SERVICE BULLETIN

HN-238 DN-187 EN-80 FN-66

DATE: 26 OCTOBER 1994

TAIL ROTOR BLADE ABRASION STRIP MODIFICATION

Figure 1. Application of Steel Tape to Tail Rotor Blade.

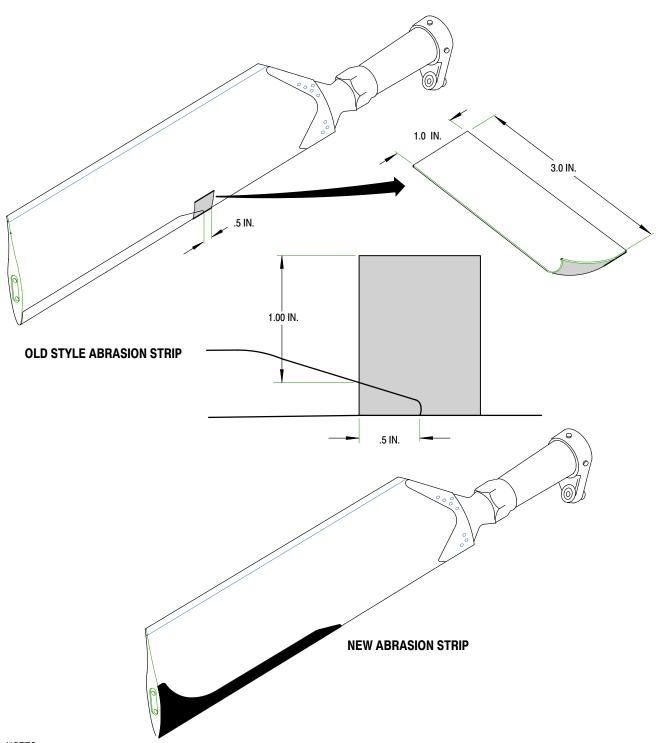
- (2). Lightly abrade faying surface of tail rotor blade in the area where the tape is to be installed with 400 grit abrasive paper (see Figure 1).
- (3). Wipe faying surface of blade with solvent to eliminate grease and dirt film.

- (4). Use heat gun or equivalent to warm blade faying surface. Temperature must not exceed 120 deg. F.
- (5). Remove backing and apply stainless steel abrasion tape to leading edge of tail rotor blade as shown in Figure 1. Apply tape so it overlaps each side of blade equally. Tape should overlap the inboard end of abrasion strip .5 in. +/- .03 at the leading edge of the blade.

NOTE: The requirements of this Notice are not required on tail rotor blades with new design abrasion strip (see Figure 1).

- 304 STAINLESS STEEL TAPE SHALL BE APPLIED; 1/2-INCH TO ABRASION STRIP AND 1/2-INCH TO TAIL ROTOR BLADE.
 APPLY TAPE EQUALLY TO BOTH SIDES OF BLADE.
